Applicability

This document applies to the part numbers of STM32F031x4/x6 devices listed in [Table 1](#) and their variants shown in [Table 2](#).

[Section 1](#) gives a summary and [Section 2](#) a description of device limitations and documentation errata, with respect to the device datasheet and reference manual RM0091.

Figure 1. Masked RTC interrupt

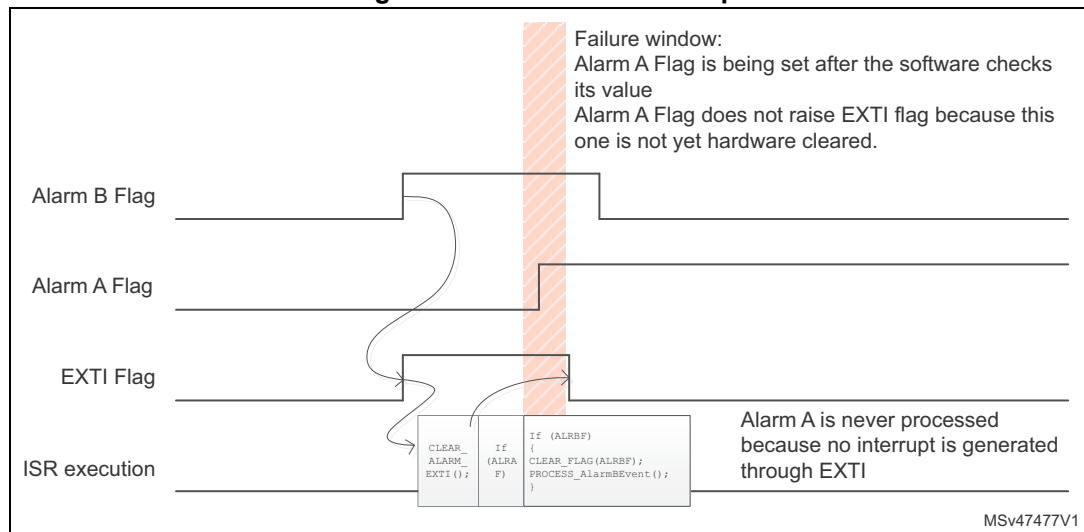
One RTC interrupt can mask another RTC interrupt if both share the same EXTI configurable line, such as the RTC Alarm A and Alarm B, of which the event flags are OR-ed to the same EXTI line (refer to the **EXTI line connections** table in the **Extended interrupt and event controller (EXTI)** section of the reference manual).

The following code example and figure illustrate the failure mechanism: The Alarm A event is lost (fails to generate interrupt) as it occurs in the failure window, that is, after checking the Alarm A event flag but before the effective clear of the EXTI interrupt flag by hardware. The effective clear of the EXTI interrupt flag is delayed with respect to the software instruction to clear it.

In the interrupt service routine, apply three consecutive event flag checks - source one, source two, and source one again, as in the following code example:

void RTC_Alarm_IRQHandler(void)
{
  CLEAR_ALARM_EXTI(); /* Clear the EXTI's line Flag for RTC Alarm */
  If(ALRAF) /* Check if AlarmA triggered ISR */
  {
    CLEAR_FLAG(ALRAF); /* Clear the AlarmA interrupt pending bit */
    PROCESS_AlarmAEvent(); /* Process AlarmA Event */
  }
  If(ALRBF) /* Check if AlarmB triggered ISR */
  {
    CLEAR_FLAG(ALRBF); /* Clear the AlarmB interrupt pending bit */
    PROCESS_AlarmBEvent(); /* Process AlarmB Event */
  }
  If(ALRAF) /* Check if AlarmA triggered ISR */
  {
    CLEAR_FLAG(ALRAF); /* Clear the AlarmA interrupt pending bit */
    PROCESS_AlarmAEvent(); /* Process AlarmA Event */
  }
}

Figure 2. WLCSP25 package marking

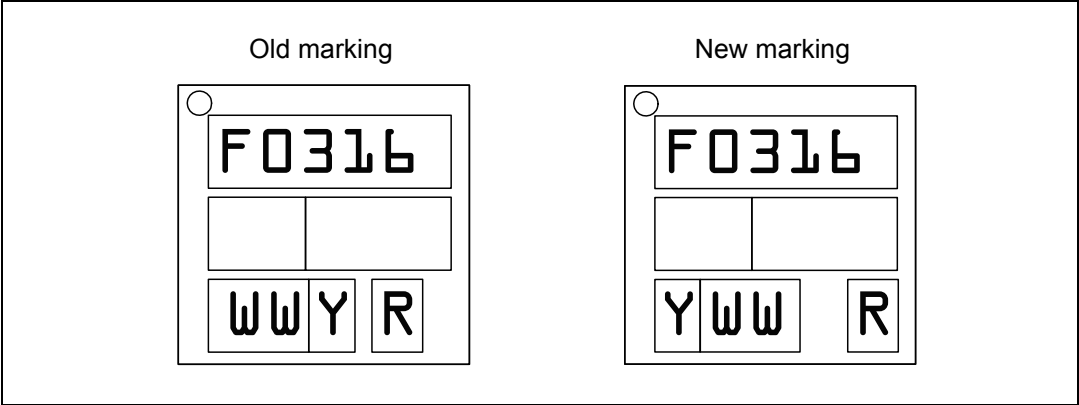
Until week 9 of 2017, the date code on the WLCSP25 package was marked in the format WWY (two digits for week followed by one digit for year), while the figure giving the example of package marking in the product datasheet was showing the inversed sequence YWW.

From week 9, 2017 on, the marking on the WLCSP25 package is modified to show the date in the format YWW. [Figure 2](#) illustrates the difference between the old and the new product marking. The figure in the product datasheet was also updated to better reflect the dimensions and layout of the marking on the package.
